| Department; **Outfitting System Design 1** | Ship Type; **157,000DWT Crude Oil Tanker** | Class.; **LR** |
| Approved by ; Y. S. Kim<br>Checked by ; Y. S. Park<br>Prepared by ; H. B. Choi (T.5572) | Document Title; **PIPING DIAGRAM OF ENGINE ROOM** | |
| **SAMSUNG HEAVY IND. CO., LTD.**<br>**GEOJE SHIPYARD, KOREA** | Builder's Document No.; **MB10100** | Rev. No.; **C** |

REVISION HISTORY ( 1/ 1 )

| SYS/DWG/PAGE | S05 |

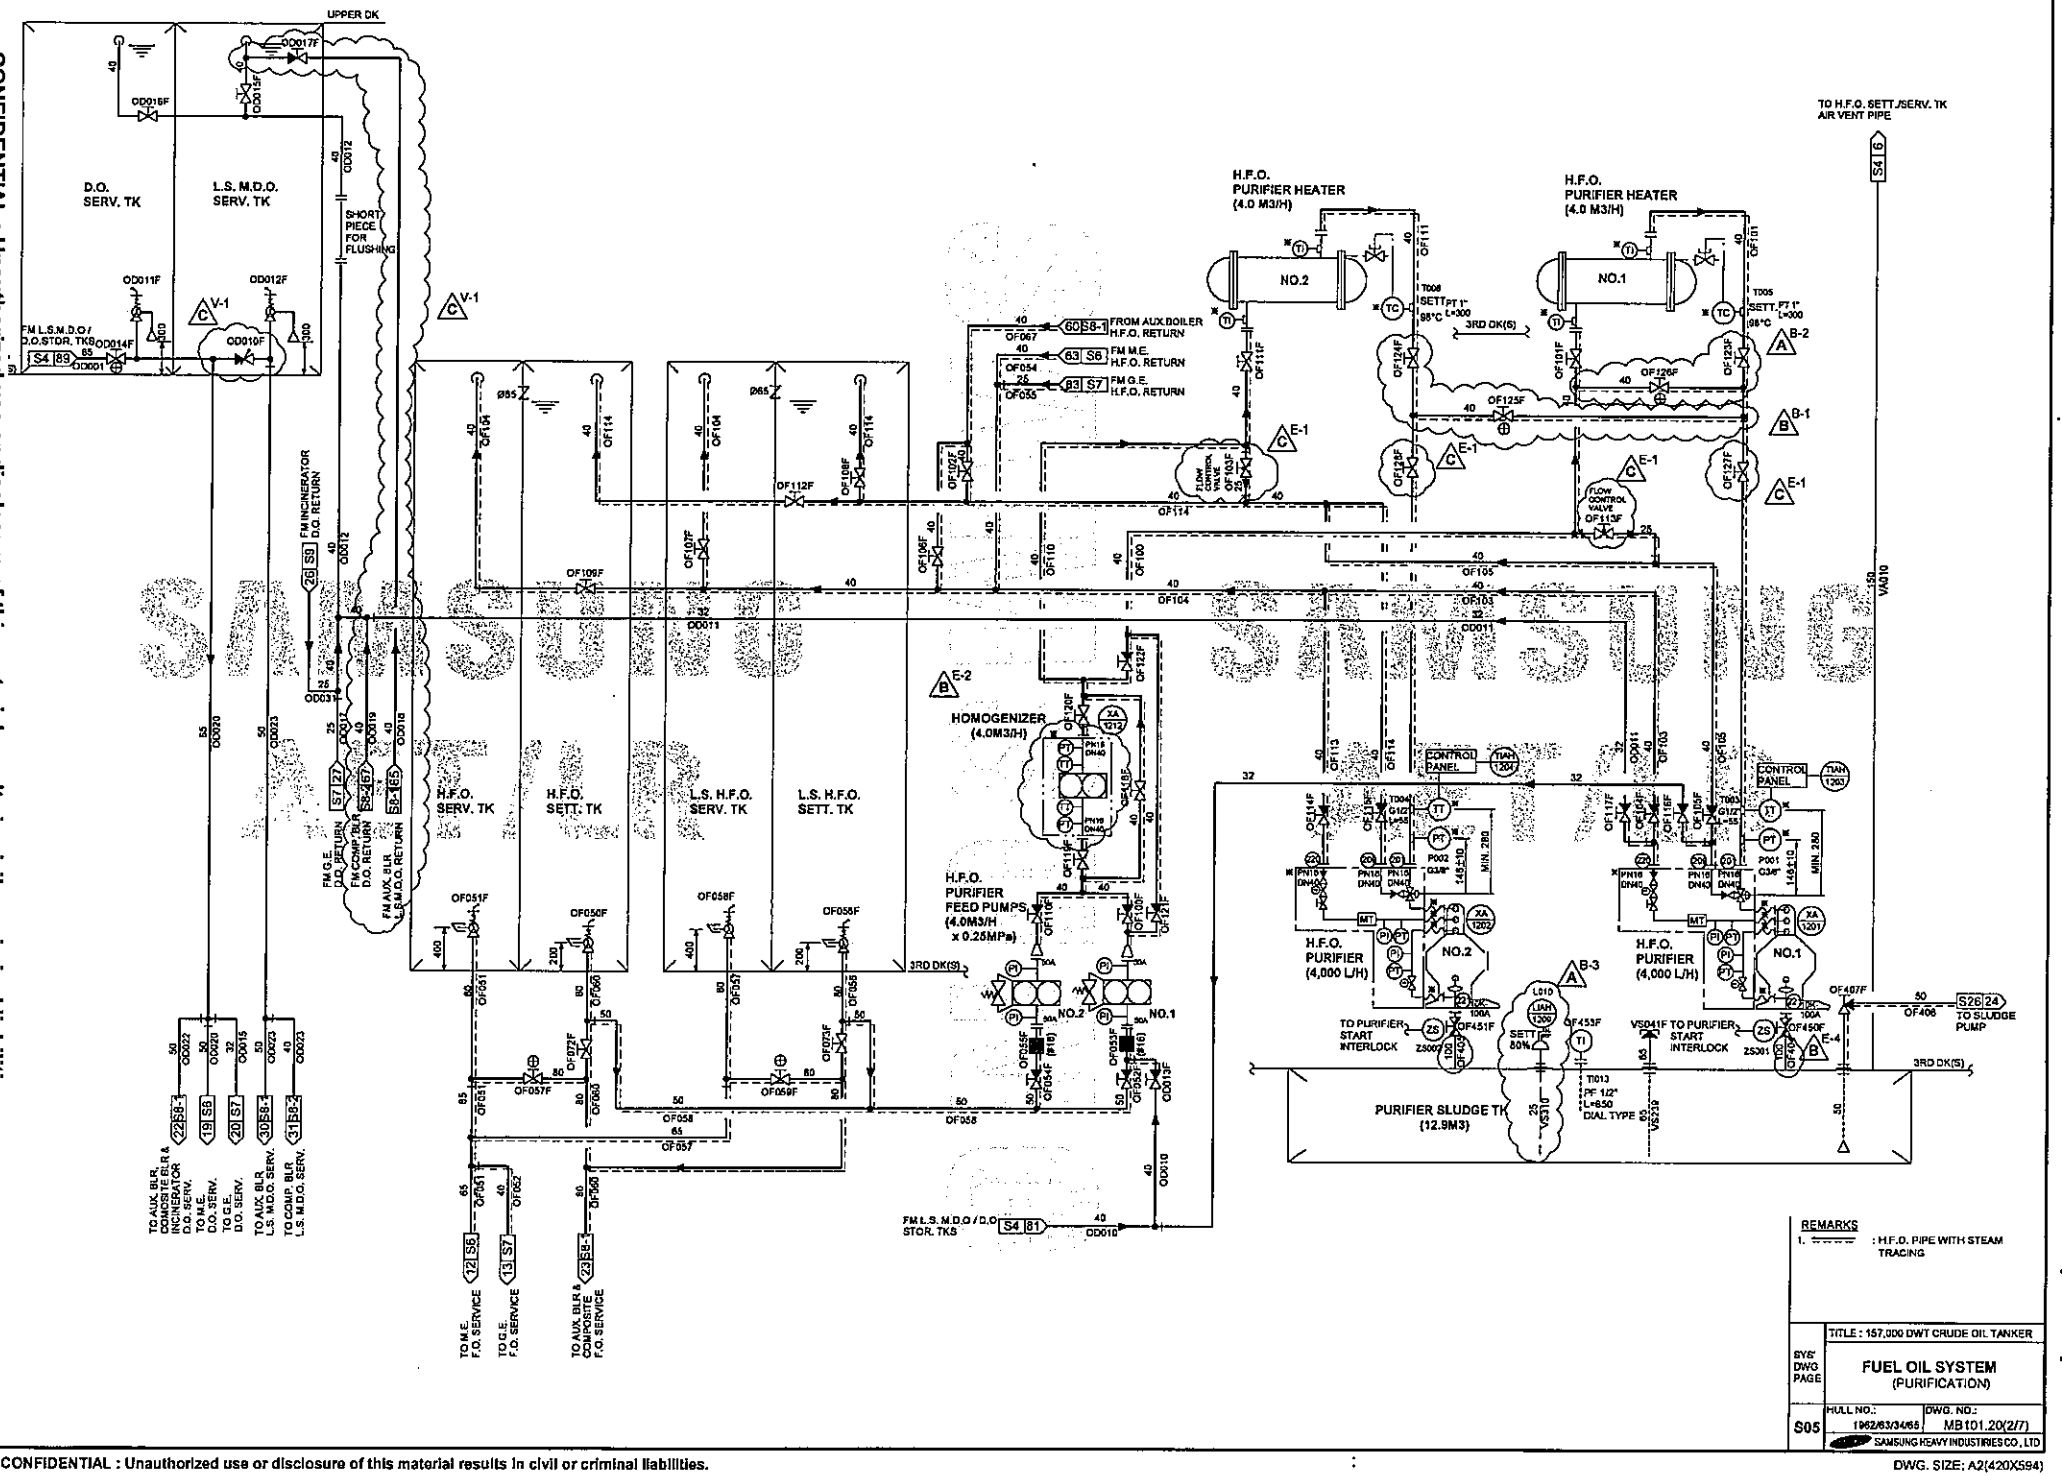
| ALT. NO. | Rev. NO. | DESCRIPTION | SYS. PAGE |
|---|---|---|---|
| | E-2 | - Internal drawing of homogenizer was changed. | S05, S09 |

| ALT. NO. | Rev. NO. | DESCRIPTION | SYS. PAGE |
|---|---|---|---|
| | V-1 | - Following items were modified .<br>- L.S. M.D.O. supply/return line and revelant pipe , valve was modified in order to prevention of D.O/L.S. M.D.O contamination.<br>- Quick closing valve unit(G472) was changed. | S05, S08-1 |

| SYS' DWG PAGE | COMPRESSED AIR SYSTEM (CONTROL AIR) |

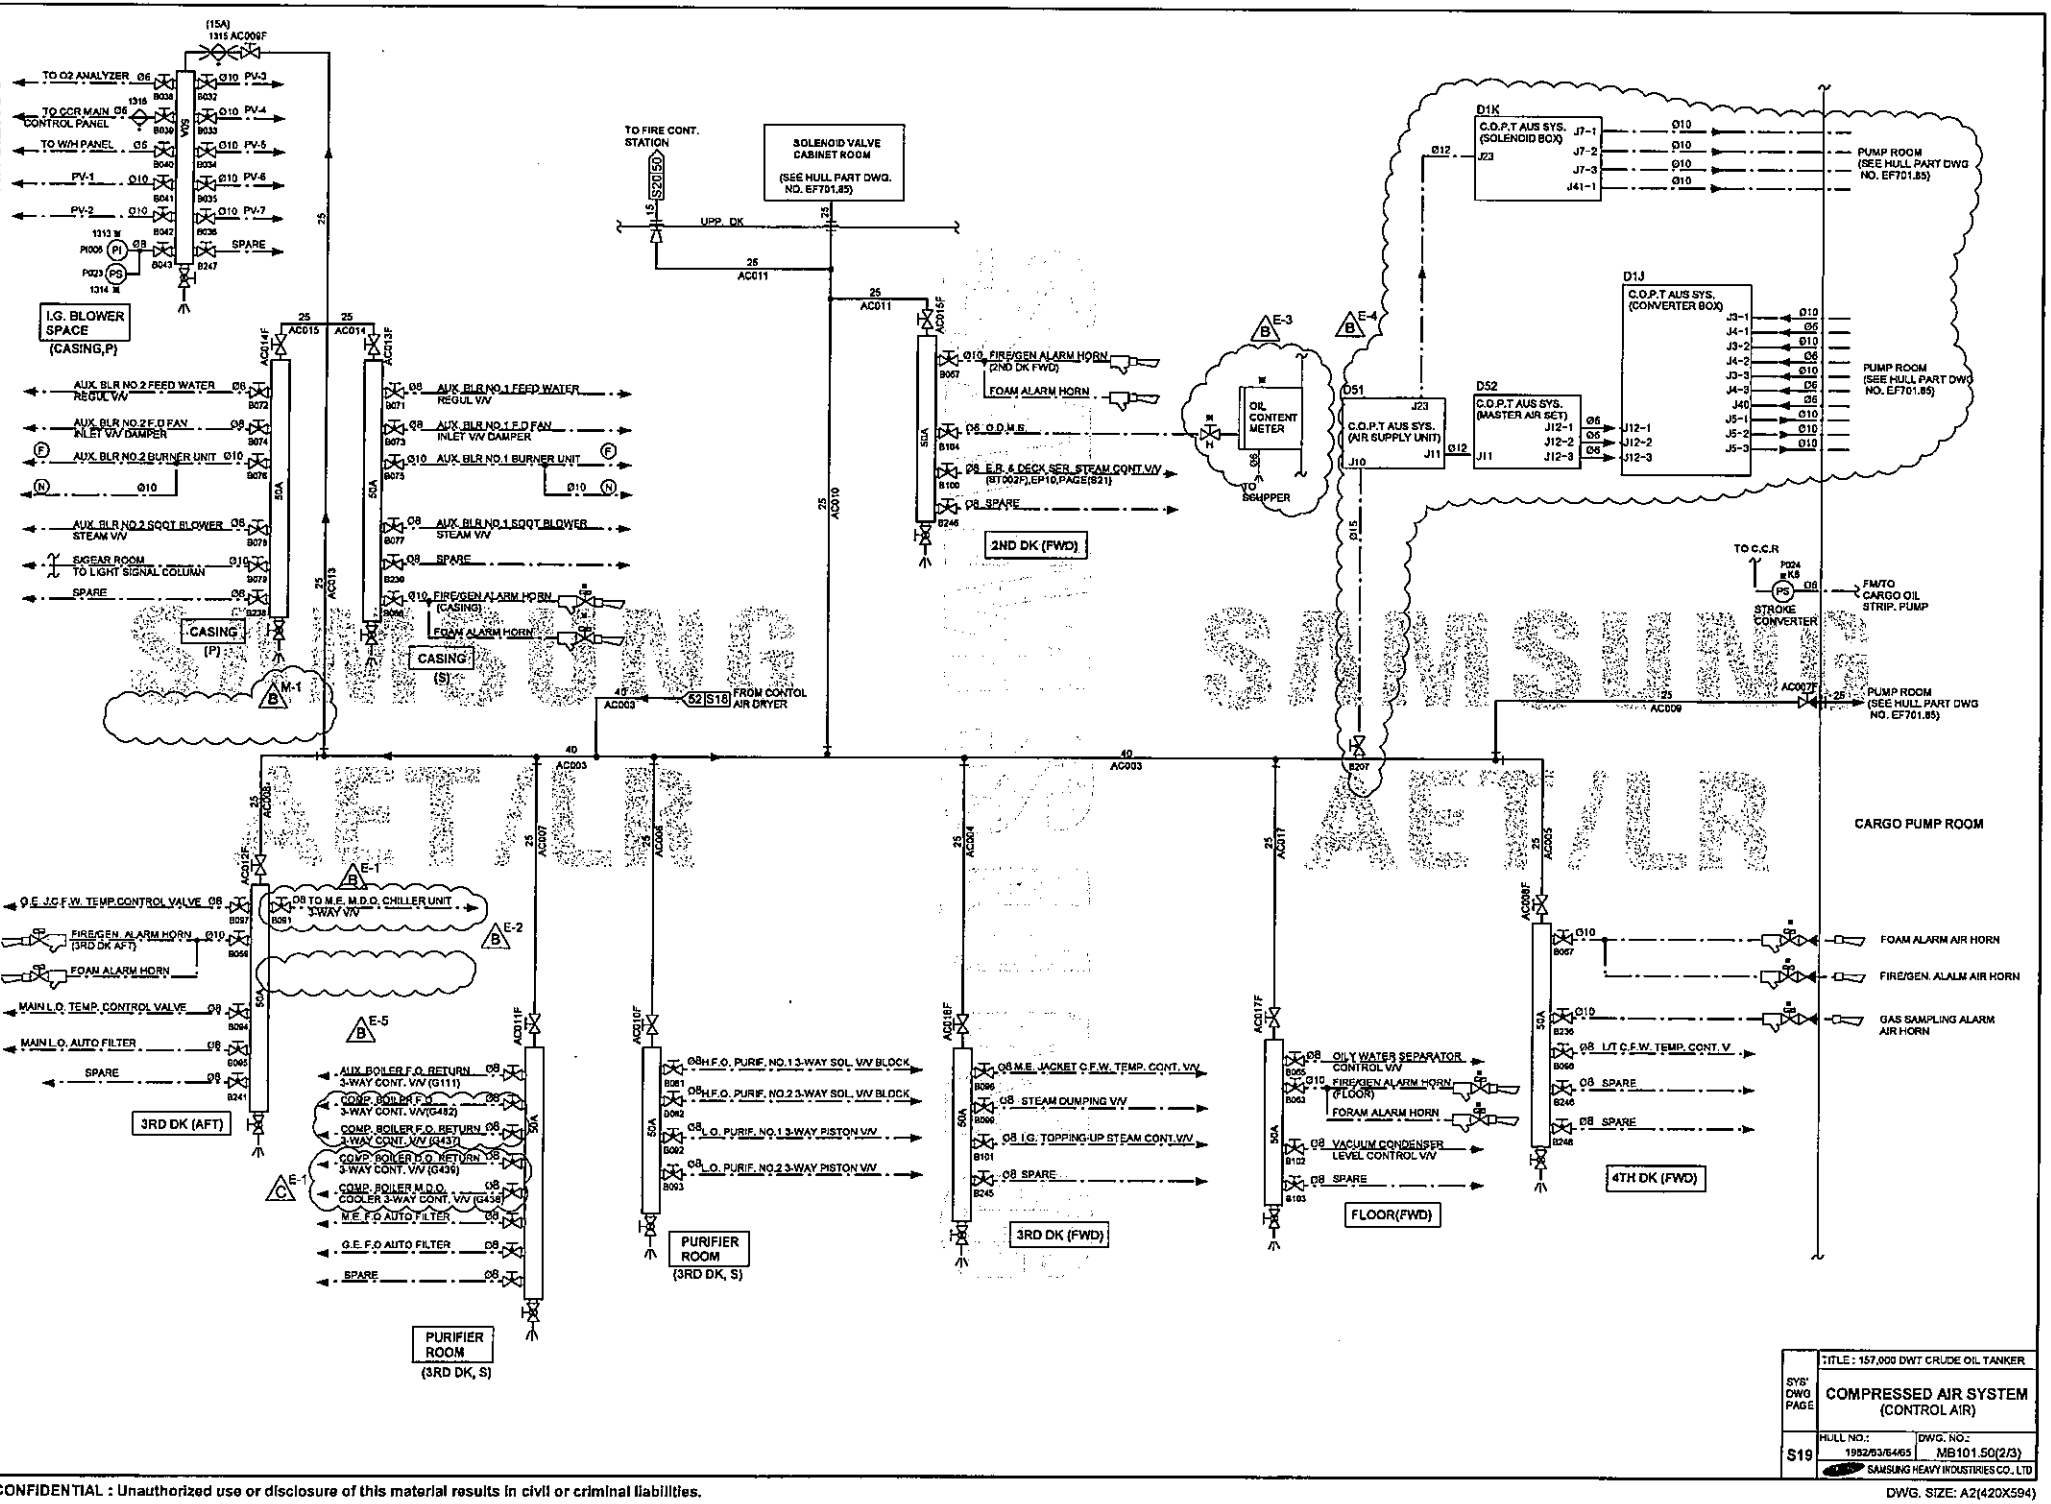
| ALT. NO | Rev. NO | DESCRIPTION | SYS. PAGE |
|---|---|---|---|
| | E-3 | - Control air line for O.D.M.S was identified in detail. | S19 |
| | E-4 | - Control air line for A.U.S.(Automatic Unloading System) was identified in detail. | S19 |

PIPING DESIGN SPECIFICATION (PS6) (1/1)
(EXHUAST GAS SYSTEM) (MB101.60) (S21)

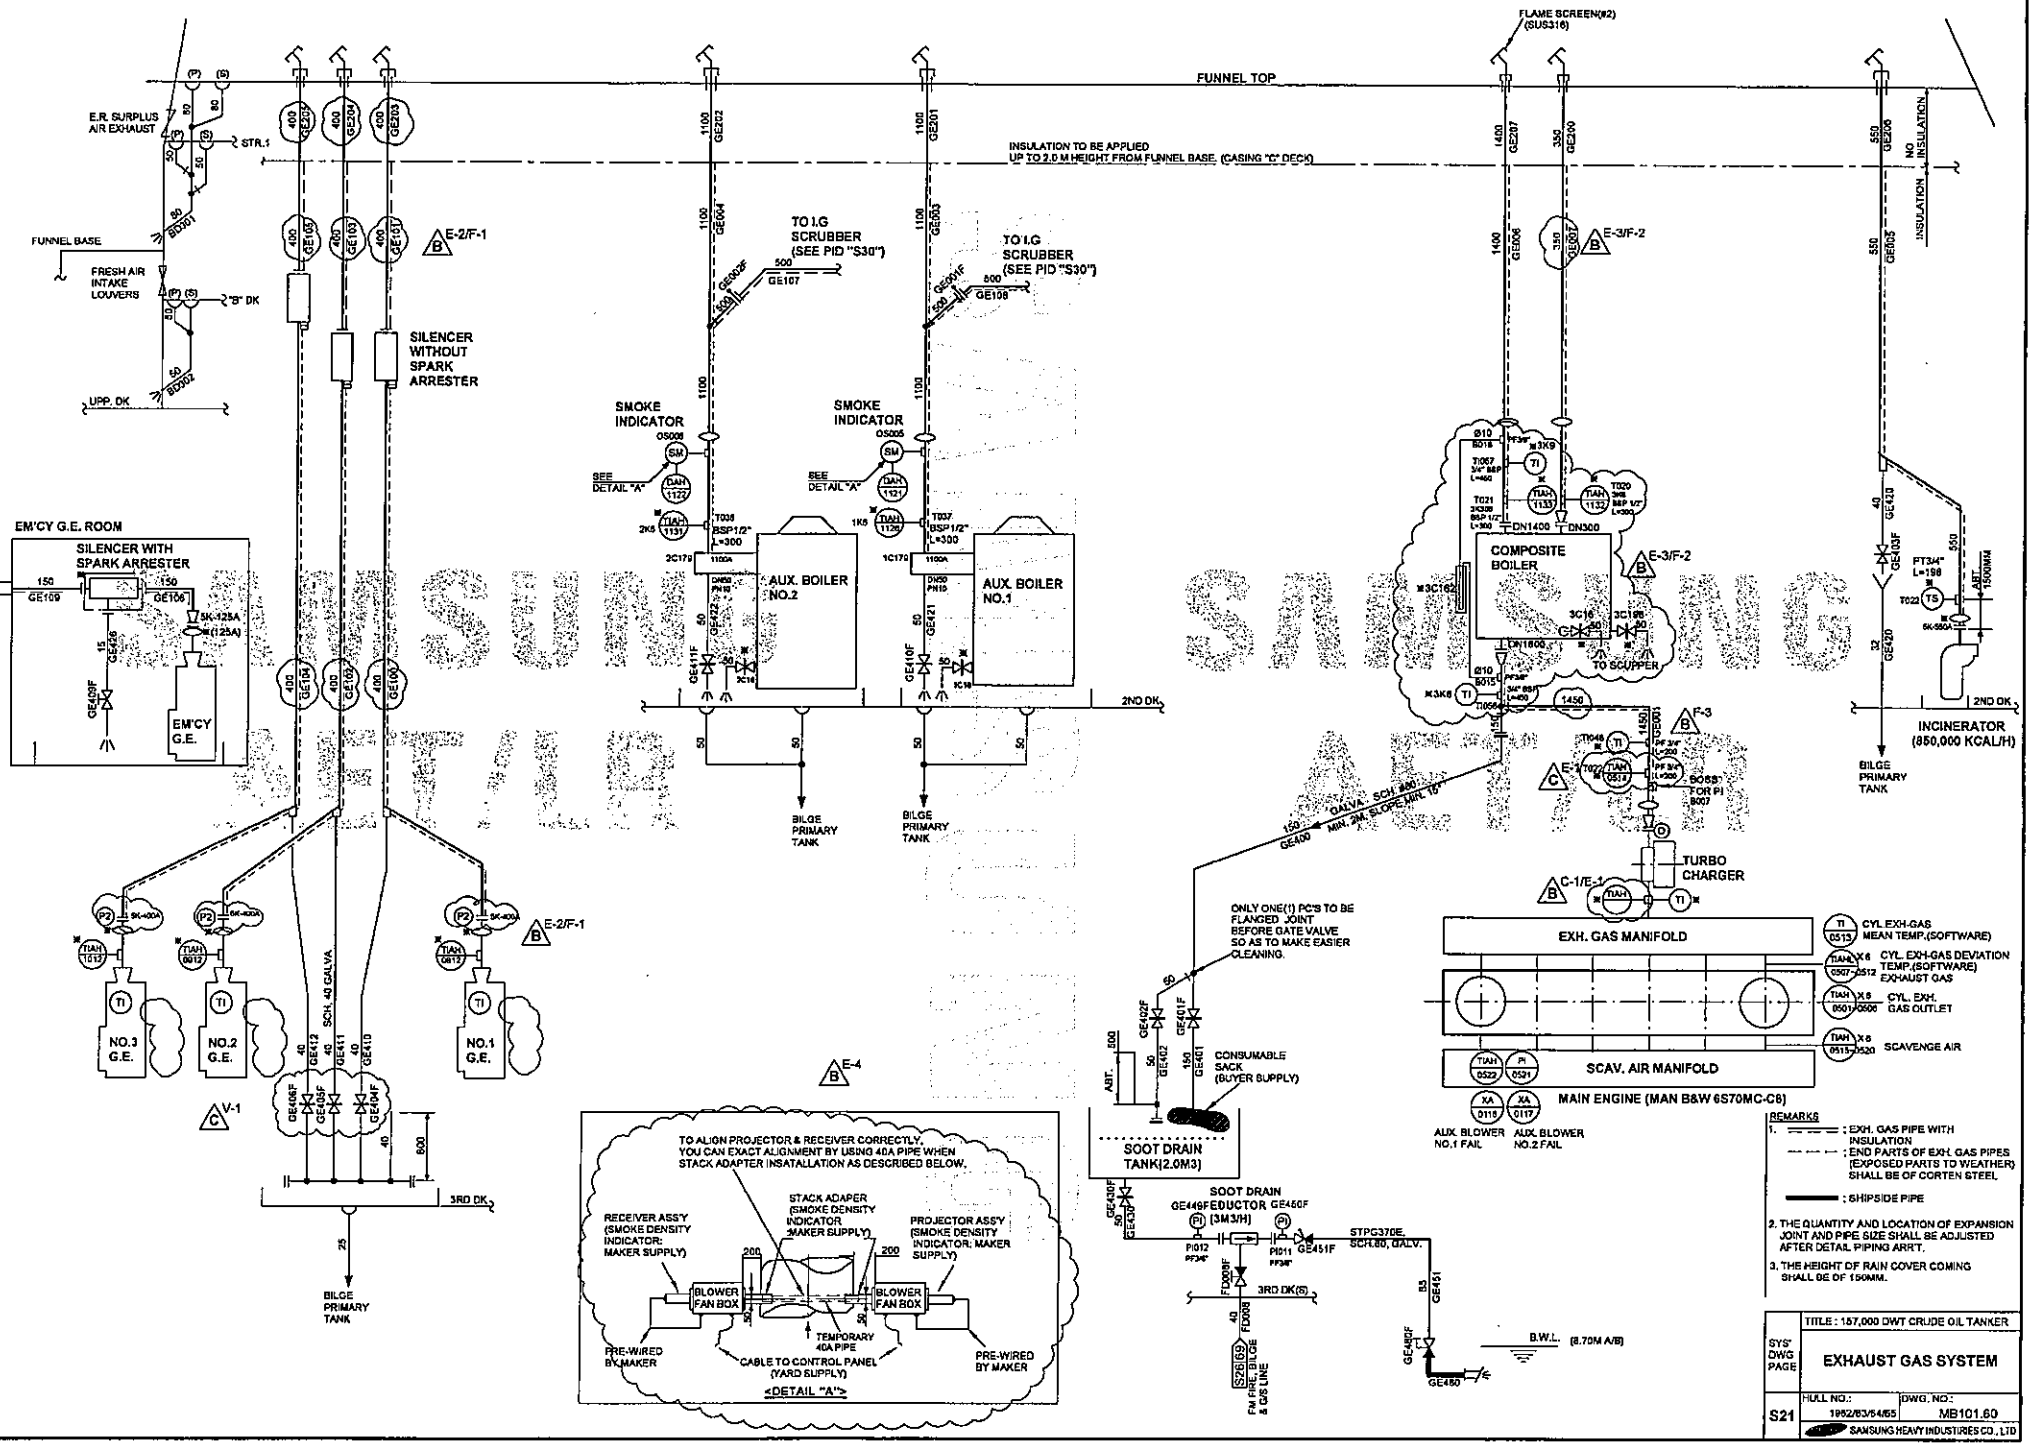
| ALT. NO. | Rev. NO. | DESCRIPTION | SYS. PAGE |
|---|---|---|---|
| | E-2/F-1 | - Exhaust pipe size of G.Es was increased to 400A from 350A and internal drawing of G.Es was changed. | S21 |
| | E-3/F-2 | - Smoke uptake pipe size of Composite boiler was increased to 350A from 300A and internal drawing of Composite boiler was changed. | S21 |
| | E-4 | - Detail drawing for Smoke indicator was revised. | S21 |
